### Mounting of new type of energy regulators in place of old ones

Old type of energy regulator

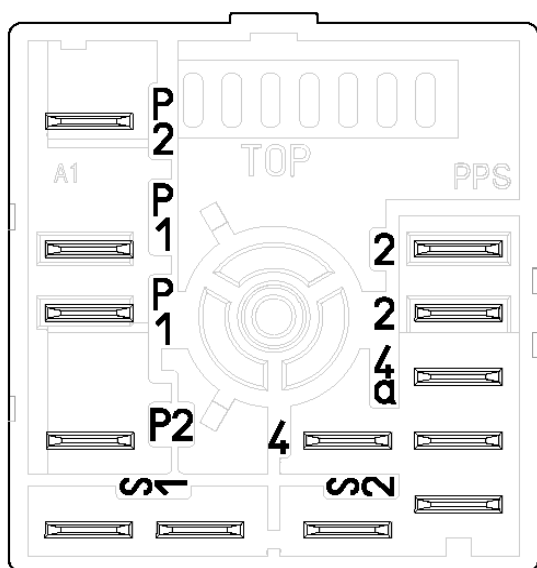
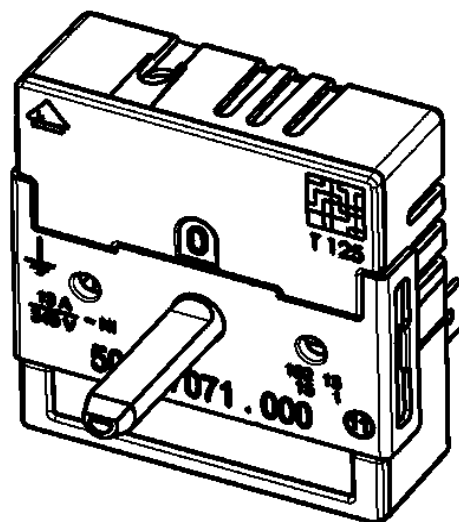
In cookers, construction of energy regulators has been modified. Location for flat connectors has been changed and size of energy regulators has been modified.

In order to mount new energy regulators in appliances equipped with old type of energy regulators, it is required to connect all harnesses with suitable flat connects according to new layout of energy regulator.
